## City Council Oak Bend Subdivision Phase I Preliminary Plat

October 03, 2024

#### PRELIMINARY PLAT ESTABLISHING OAK BEND SUBDIVISION PHASE I

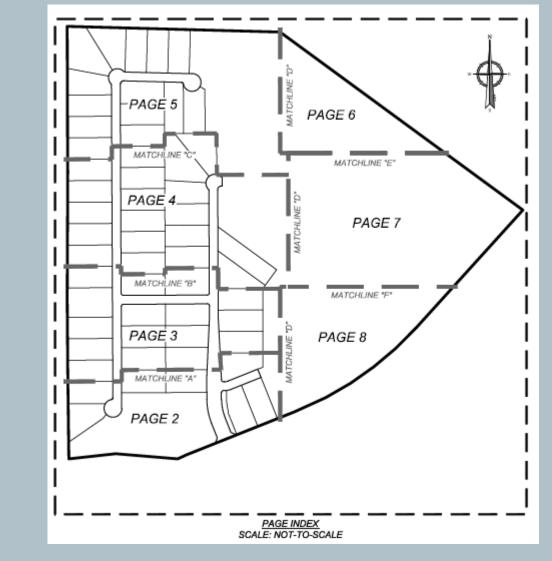
- 1. The approved variance (PV-2024-01) shall apply to only the thirty-eight (38) lots that do not meet the 150-foot street frontage requirement as presented.
- 2. Applicant to confirm that the proposed development complies with all applicable sections of the Chapter 10 Subdivision Regulations.
- 3. Applicant to show that the street, Bald Cypress Court, will be connected to the adjoining street on the east in Phase II in the future and add a note to the plat regarding this.
- 4. Applicant to remove building setback legend from the "existing keynotes" (previously titled as "key notes") on all pages. All setback requirements need to meet the zoning requirements of Neighborhood Residential (NR) District.

- 5. Applicant to provide metes and bounds description to verify all coordinate points on plat. The coordinates and distances indicated in the metes and description in the warranty deed do not match the coordinates and distances called out on the plat.
- 6. Applicant to add a plat note stating approval of this plat vacates the approved and recorded Oak Bend Estates Plat.
